DART SERVICE INSTRUCTION

TO AMEND INSTALLATION INSTRUCTIONS: IIN-D206-667 REV. C
 REF. CANADIAN STC: SH01-5
 REF. FAA STC: SR01304NY

DESIGN	PH	DART AEROSPACE LTD	
DRAWN	GP	HAWKESBURY, ONTARIO, CANADA	
CHECKED	[Signature]	DRAWING NO.	REV. K
MFG. APPR.	N/A	DSI 9346	
APPROVED	[Signature]	SHEET 1 OF 2	
DE APPR.	[Signature]	TITLE	SCALE
DATE	11.03.08	DEVIATION ON D206-667 & D407-667	
		NTS

FIGURE 1 - INSTALLATION OF DART CROSSTUBES ON BHT/AAI SKIDTUBE

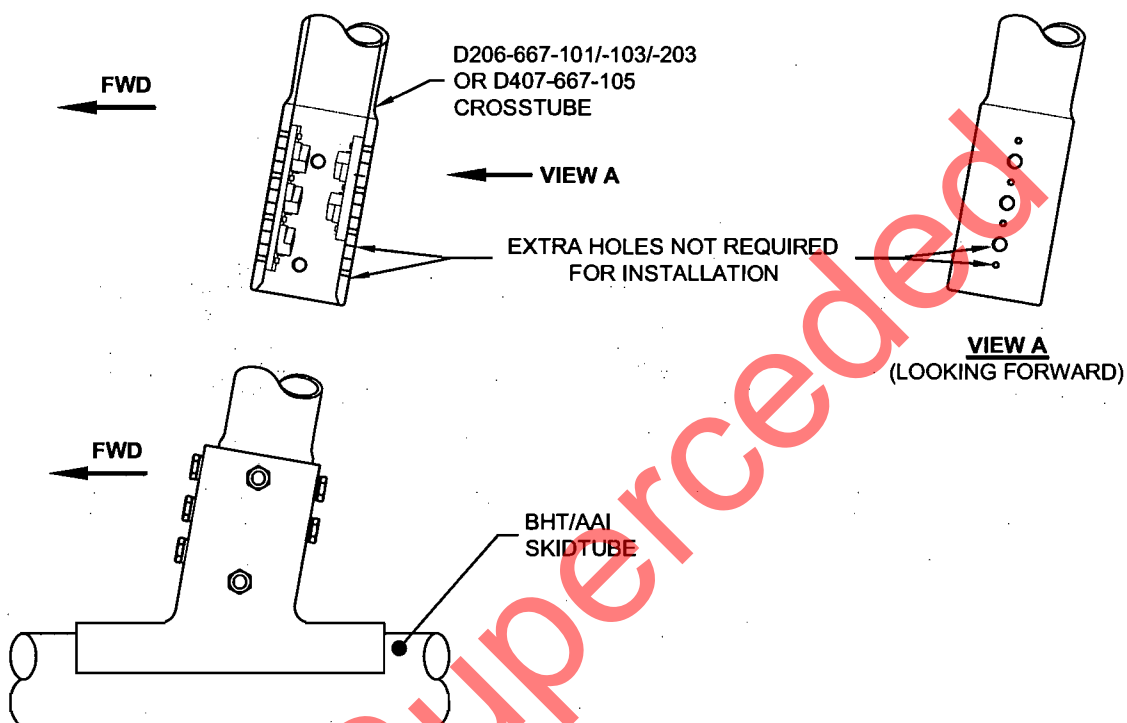
THE FOLLOWING D206-667-101/-103/-203 AND D407-667-105 CROSSTUBES HAVE EXTRA HOLES DRILLED ON THE AFT SIDE OF THE CUFFS. THIS HOLE IS NOT REQUIRED FOR INSTALLATION OF DART CROSSTUBES ONTO BHT/AAI SKIDTUBES AS SHOWN IN FIGURE 1.

CUSTOMERS RECEIVING CROSSTUBES AT CHG 002 PRIOR TO 06.08.08 SHOULD CONTACT DART FOR DISPOSITION IF INSTALLING THE DART CROSSTUBES ONTO BHT/AAI SKIDTUBES PER IIN-D206-667 REV. C.

CUSTOMERS RECEIVING CROSSTUBES AT CHG 002 PRIOR TO 06.08.08 TO BE INSTALLED WITH DART SKIDTUBES MAY FIND THAT THE SUPPORTS HAVE BEEN INSTALLED BACKWARDS. THE SUPPORTS SHOULD BE REMOVED AND RE-INSTALLED PER ICA-D206-667.
